Errata Sheet

V1.0, 2007-09

Device	**C504-2E**
Marking/Step	**Step CC**
Package	**P-MQFP-44**

Figure 1 Reset Circuitries

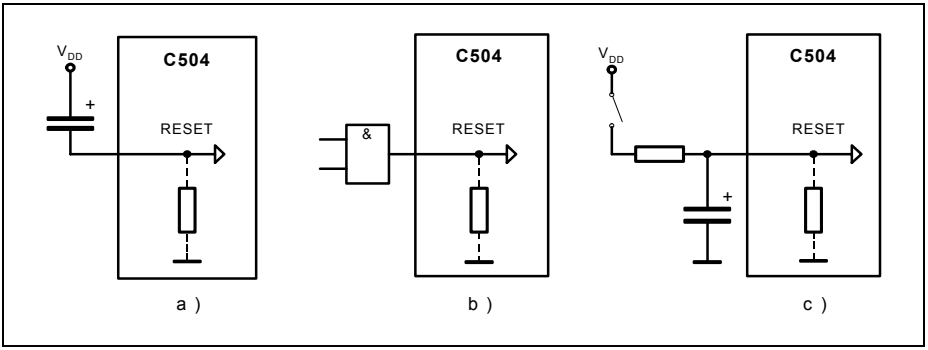
RST.1: Figure in User’s Manual and Data Sheet regarding the Reset Circuitries is incorrect

Figure 5-1 in User’s Manual and Figure 6 in Data Sheet show incorrectly that the RESET pin has an internal pullup resistor connected to the V_{DD}. Instead, at the RESET pin, an internal pulldown resistor is connected to the V_{SS}. The correct implementation is illustrated in **Figure 1**.

This correction will be updated to the future versions of the User’s Manual and Data Sheet.
